SB Number:	SB 2G1-011	Creation Date: 17/04/2008
Subject:	Prevent fuser thermistor detection error (prevent call C-6020)	
Model:	FS-9130DN/9530DN

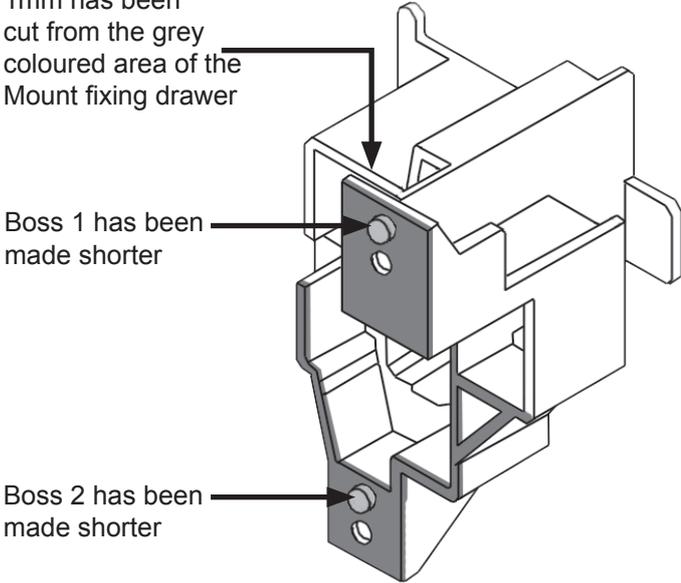
Contents of changes	<p>To prevent Service call C-6020 the Engine firmware has been upgraded and Wire primary C has been changed (see Service bulletin 2G1-013 for details). Following changes have been made to further improve the engagement between the fuser and the main body drawers.</p> <ol style="list-style-type: none"> 1. The shape of Mount fixing drawer (No.1) has been changed, so replace Mount fixing drawer 2BL26290 with Mount fixing drawer 302GR39220 (see page 2 for details) 2. The connector at the main body side has been shifted 1mm to improve the connection.
----------------------------	---

Changes made to the Mount fixing drawer	<p>1mm has been cut from the grey coloured area of the Mount fixing drawer</p>  <p>Boss 1 has been made shorter</p> <p>Boss 2 has been made shorter</p>
--	---

Parts	No.	Old Parts No.	New Parts No.	Description	Q'TY		Interchange-ability		SP
					Old	New	Old	New	
	1	2BL26290	302GR39220 2GR39220	MOUNT FIXING DRAWER	1	1	X	O

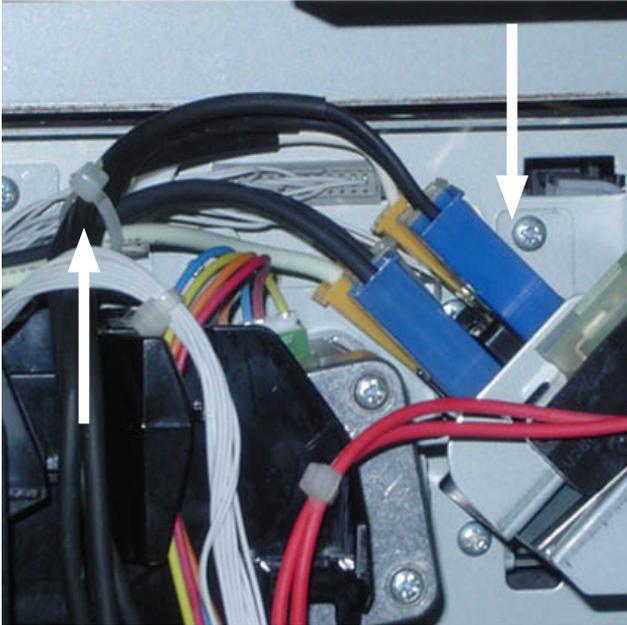
Cut the binding band, and be careful that the wires do not get damaged.
Then remove blue, white and yellow connectors on the upper right.

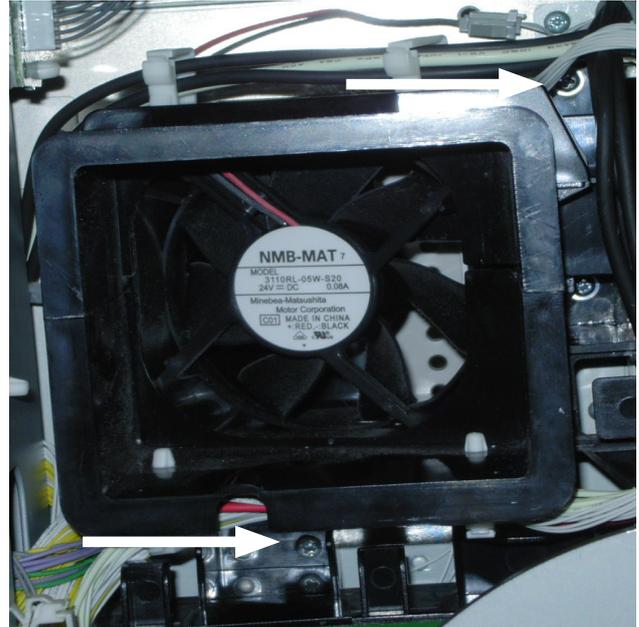
Remove the screws that hold the fan.
This is not to remove the fan, but to create enough space to remove the Mount fixing drawer.

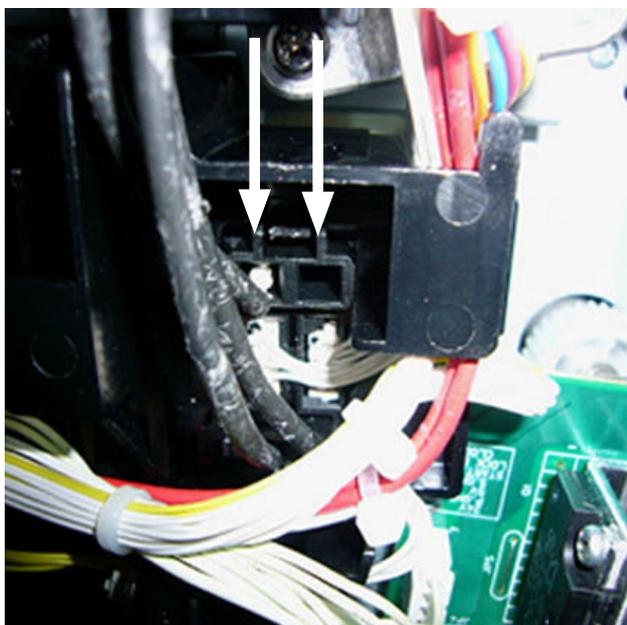
Remove the 2 connectors (C216/C225) from the Wire primary c that is connected to the Mount fixing drawer (2BL26290).

Take the connector out of the Motor feed (302GR4260), then remove the 2 screws that hold the Mount fixing drawer.
Now remove Mount fixing drawer 2BL26290 and replace this with Mount fixing drawer 302GR39220.
